Volare Carburetors, LLC

Service Bulletin: SB-3 Rev A

SUBJECT – HA-6™ ACCELERATOR PUMP PLUNGER.

Figure 2
Close up showing wear from Retaining Clip.

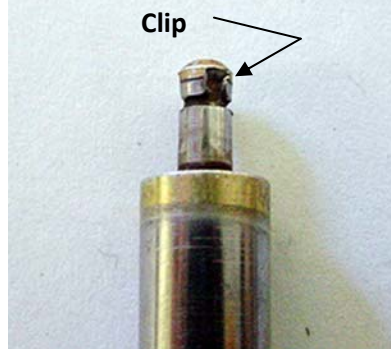
- 3. Background:** The attached photos show pump stems having severe wear above the retaining clip grooves (Figs 1 & 2). Normal stems (Figs 4 & 5) are shown for reference. Volare is not aware of instances of such advanced wear in stems manufactured by Volare. The rough surface-finish (center, Fig. 1) and worn clip grooves (outer stems, Fig. 3), are not similar to design specifications for stems manufactured by Volare.

Note: Wear from Retaining Clip

- b. Within 25 hours of operation after the date of this FLIGHT SAFETY Service Bulletin or prior to March 15, 2009, whichever comes first, remove the bowl cover and inspect the accelerator pump stem. No discernable wear in the clip groove is permitted. Replace any stem exhibiting a rough surface finish, a non-standard groove/head configuration and/or wear in the clip groove, however slight, with a NEW plunger assembly (part number is carburetor model dependent), a NEW pump rod guide, part number 88-92 and a NEW clip, part number 78-A295 supplied by Volare on or after March 4, 2008.

Figure 3
Machining differences among different stems

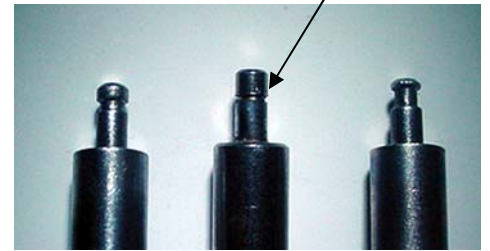
Center Stem is Good

Figure 6
Stamp Flange with 'AP' in location shown after compliance with this service bulletin SB-3.

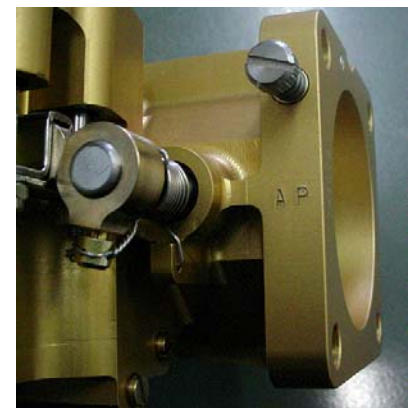
7. **Identification/Marking:** Upon completion of this Flight Safety Service Bulletin, stamp the letters “AP” in letters 1/8-inch tall (nominal) on the side of the carburetor flange below the idle mixture needle approximately midway between the upper and lower bolt holes (Fig 6).
